# Access Compliance Report

## Public Rights-of-Way

### (Curb Ramps)

| Intersection ID: 46951 | Main Street: PROVIDENCE_RD | Cross Street: OLDE_WHITE_LN | Location: SW           |

| ADA ID: 81759591BE0E   | Ramp Type: PerpDiag        | Initial Pass/Fail: Fail     | Overall Compliance: No |

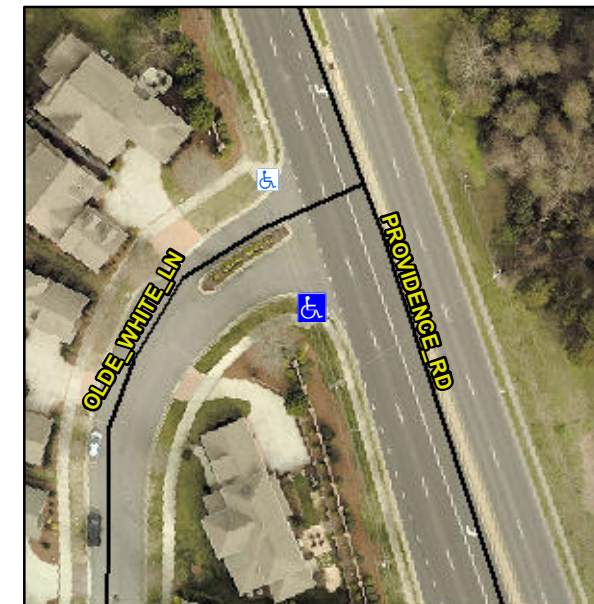
**R304.5.1, R304.5.3**

| Compliance | Description           | Data | Compliance | Description                 | Data |
|------------|-----------------------|------|------------|-----------------------------|------|
| No         | Ramp Width (in)       | 47.0 | No         | Ramp XSlope (%)             | 12.1 |

**Remove & Replace Curb Ramp With Two New Directional Ramps or Equivalent.**
